DOE/EIS-0111F

Final Environmental Impact Statement

**REMEDIAL ACTIONS AT THE FORMER
VANADIUM CORPORATION OF AMERICA
URANIUM MILL SITE
DURANGO, LA PLATA COUNTY,
COLORADO**

OCTOBER, 1985

FIGURE 4.2
GENERALIZED GEOLOGY OF THE DURANGO SITE AND DRILL HOLE LOCATIONS

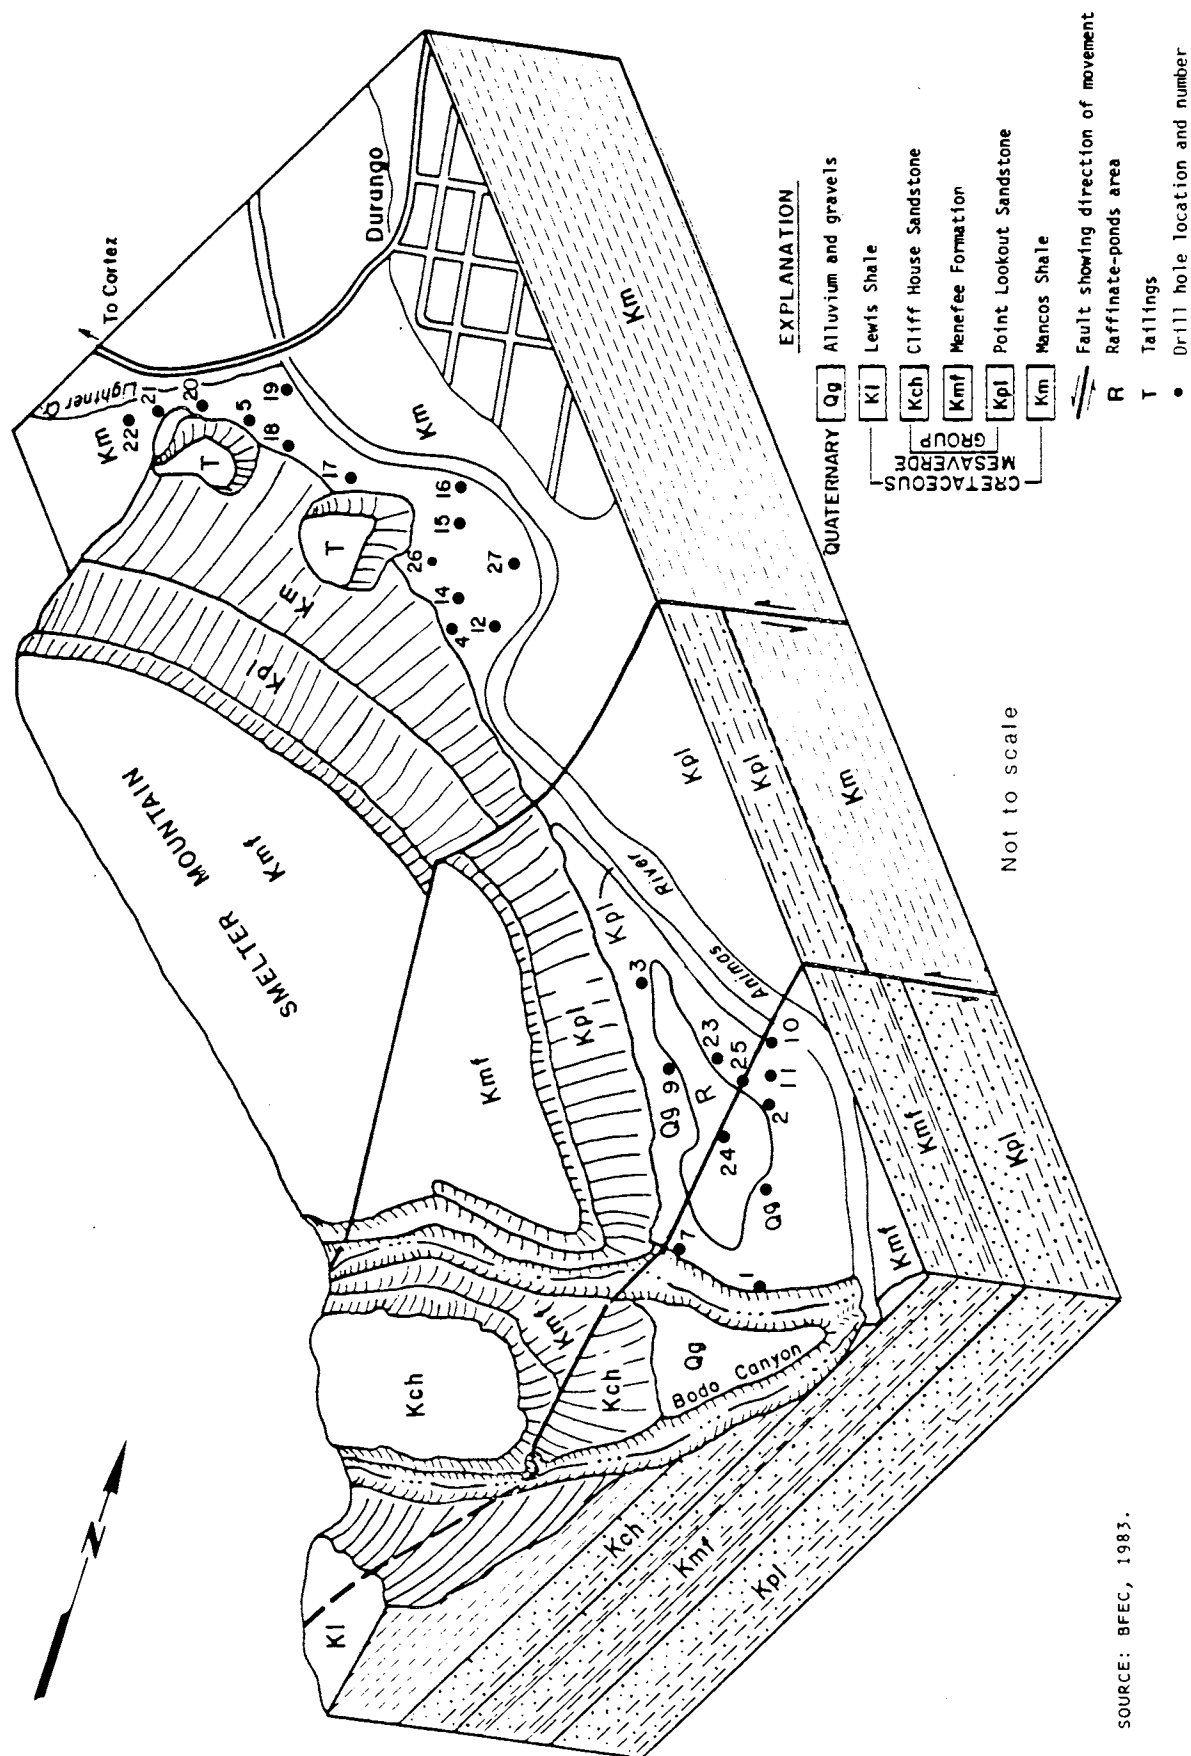
The primary source of this contamination could be vertical seepage from overlying pond areas or down-dip migration of contaminated waters from the fault zone bisecting the site (see Figure 4.2). Contamination of the underlying Point Lookout Sandstone has not been detected, except in the immediate area of the fault zone along the footwall (western) side.
